MCPB  
Item No.  
Date: 12/14/2017

**Marriott International Headquarters: Sketch Plan No. 320180060, Preliminary Plan No. 120180020, Site Plan No. 820180030**

**Summary**

- Staff recommends **Approval** of the Sketch Plan, Preliminary Plan, and Site Plan with conditions.
- The Planning Board previously approved Project Plan 920140030, Preliminary Plan 12012007A and Site Plan 820120210 for a 222-room hotel and office, which will be extinguished with this Application.

Figure 1-Site Plan

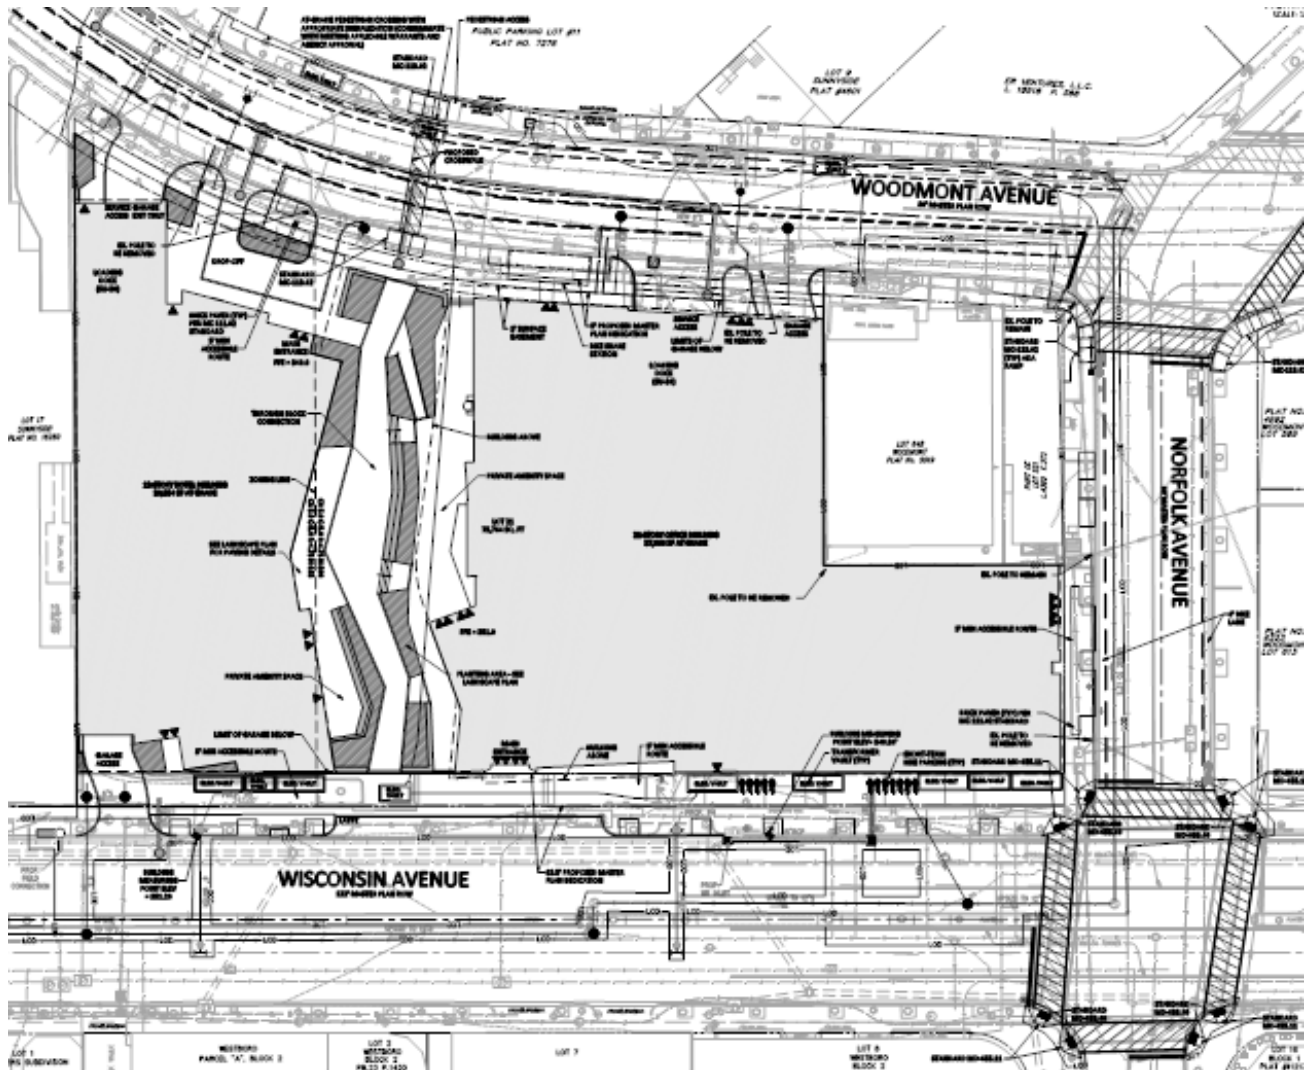
The Site Plan (Attachment B) envisions the buildings along the Wisconsin and Woodmont Avenue corridors connected by a through-block pedestrian connection. The design of the buildings is innovative and iconic, providing a unique articulation to building surfaces and providing an efficient functionality on an L-shaped site in an urban environment. The forms of each building are proportioned to create a sense of place that expresses the hospitality approach for Marriott, both corporate and community. At 165 feet, the hotel building is lower to respect the adjacent Bethesda Place office building to the south. The hotel embraces multiple facades providing different vistas and vantage points as you move through the site. The podium of the hotel offers a porte-cochere under the hotel tower and entry at the Woodmont Avenue street level serving as an arrival point while creating shelter, depth and architectural relief. The entry on Wisconsin Avenue creates a strong visual presence at the west end of the plaza that compliments the main entry to the office building. This section also protrudes above the base to provide for a second-floor terrace from the ballroom.

Figure 2-Open Space Plan

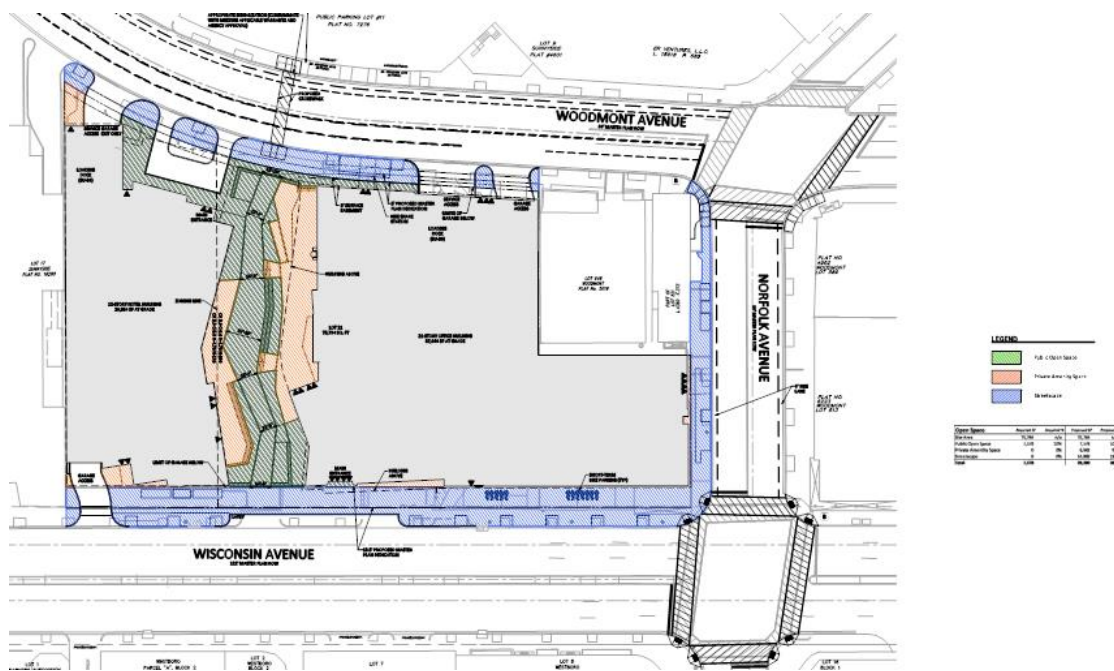
The Application includes approximately 10% of the net lot area of the Property, or 7,578 square feet as public open space, pursuant to CR zone requirements for Sites with three frontages. The proposal is for a through-block connection linking Woodmont Avenue and Wisconsin Avenue while breaking up a major block and facilitating movement between the Woodmont Triangle and the downtown core area. The connection will include specialty paving, landscaping and lighting to accent the pedestrian experience and areas of gathering near the entrances to the buildings. A larger feature tree, currently proposed as a black gum is intended to highlight the entrance to the headquarters building from Wisconsin Avenue.

Figure 3-Preliminary Plan

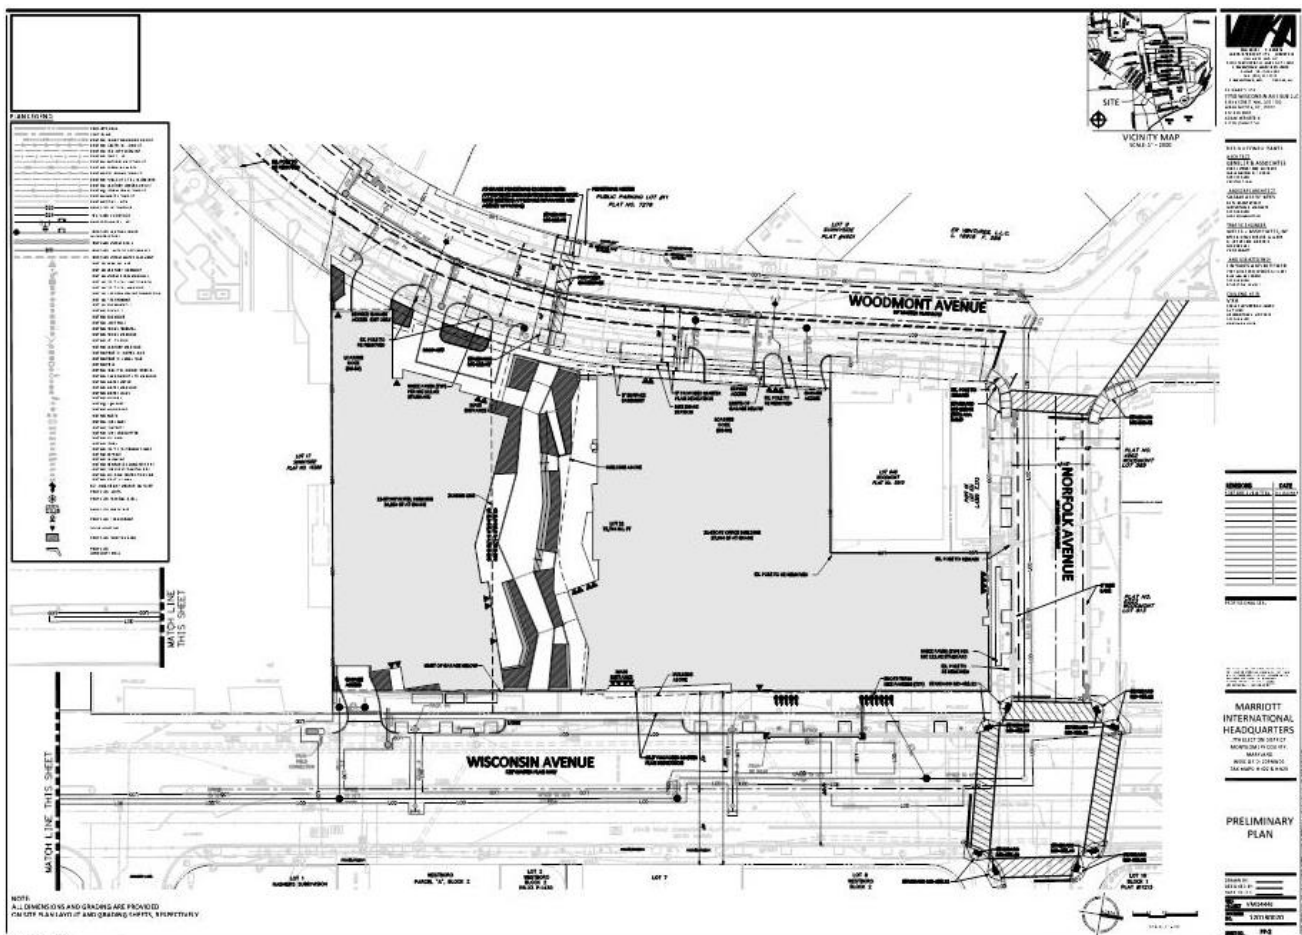
The Preliminary Plan (Attachment A) will create one lot to allow for a maximum density of 1,050,000 square feet of development of non-residential uses, with a below-grade parking structure that provides for 821 parking spaces. The subdivision will provide for a 5-foot dedication along the Property’s Woodmont Avenue frontage, supported by an additional 5-foot public utility easement; a 4-foot dedication along the Property’s Wisconsin Avenue frontage to facilitate the “running way” of the future BRT line envisioned in the Sector Plan and Master Plan of Highways. No dedication is required for Norfolk Avenue. The Project is proposed to be developed in one phase and both uses are permitted in the CR zone.

Figure 4: Circulation Plan

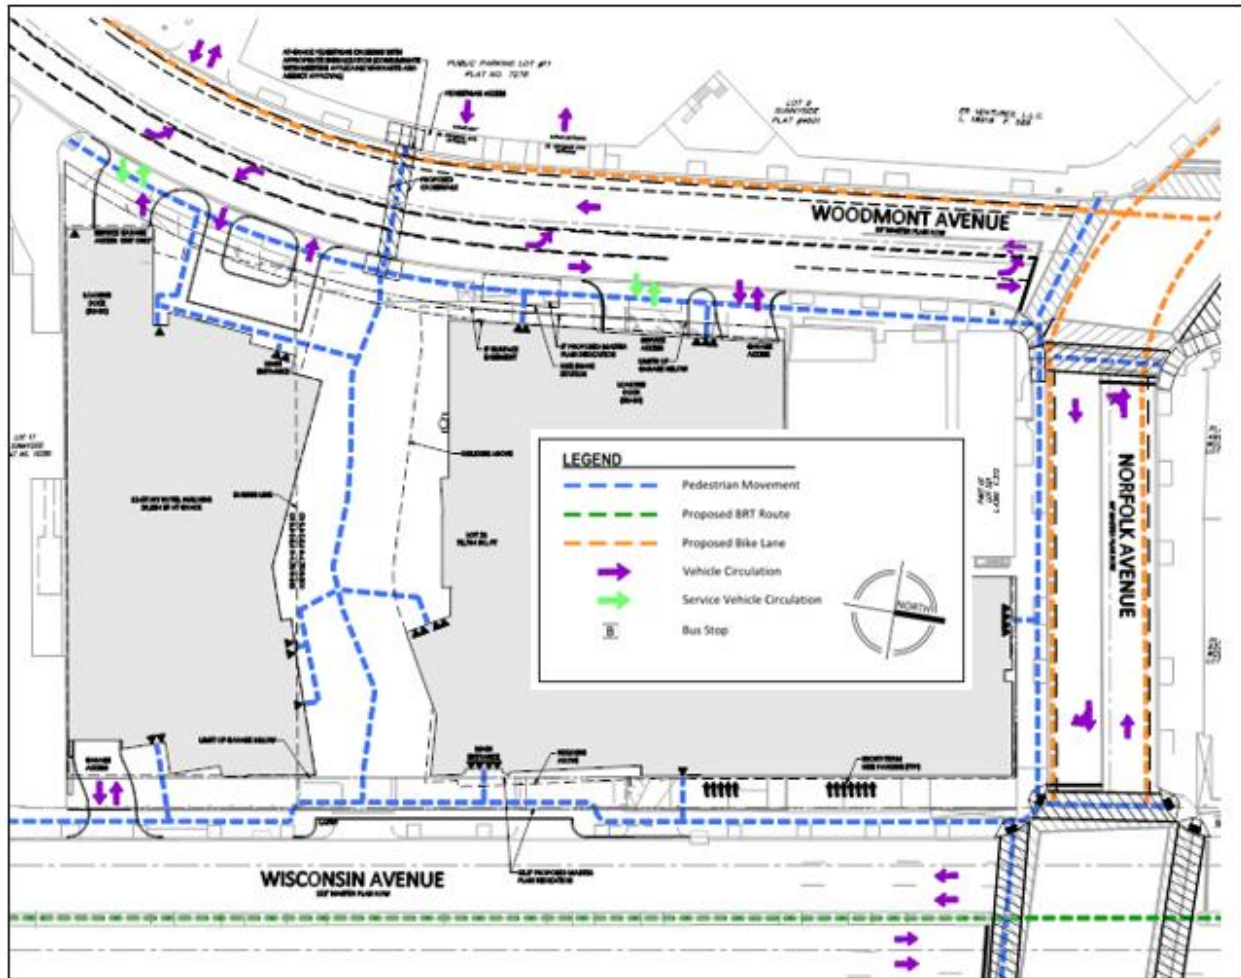
Primary vehicular access to the Property is proposed directly from both Woodmont Avenue and Wisconsin Avenue (Figure 4). All loading will occur via Woodmont Avenue on the southwest corner of the Site, adjacent to the existing parking and loading for Bethesda Place. Staff notes that the entire Site will be served by a single garage beneath the Project, containing up to 821 parking spaces, as well as Garage 11, across Woodmont Avenue. Vehicular access improvements to each of the Project's three frontages are described below:

Norfolk Avenue: Although the Application proposes a pick-up/ drop-off point for the employee daycare on the south side of Norfolk Avenue, Staff has conditioned that this use not be permitted. Such a pick-up/ drop-off area could be disruptive to traffic operations and would negatively impact the master planned bicycle lanes on Norfolk Avenue. Furthermore, Norfolk Avenue serves as gateway into the Woodmont Triangle, and provides a connection between the business district, East Bethesda, and regional traffic. No additional vehicular access points are proposed on Norfolk Avenue.

Wisconsin Avenue: The Application proposes a lay-by approximately 175-feet south of the Norfolk Avenue intersection. Approximately 75-feet south of the southern extent of the lay-by, the Application proposes a two-way garage access point for the proposed garage. As currently proposed, the access point will be a right-in/ right-out configuration, however, MCDOT and MD SHA may evaluate a new median break and traffic signal at this location in the future, if engineering warrants are satisfied.
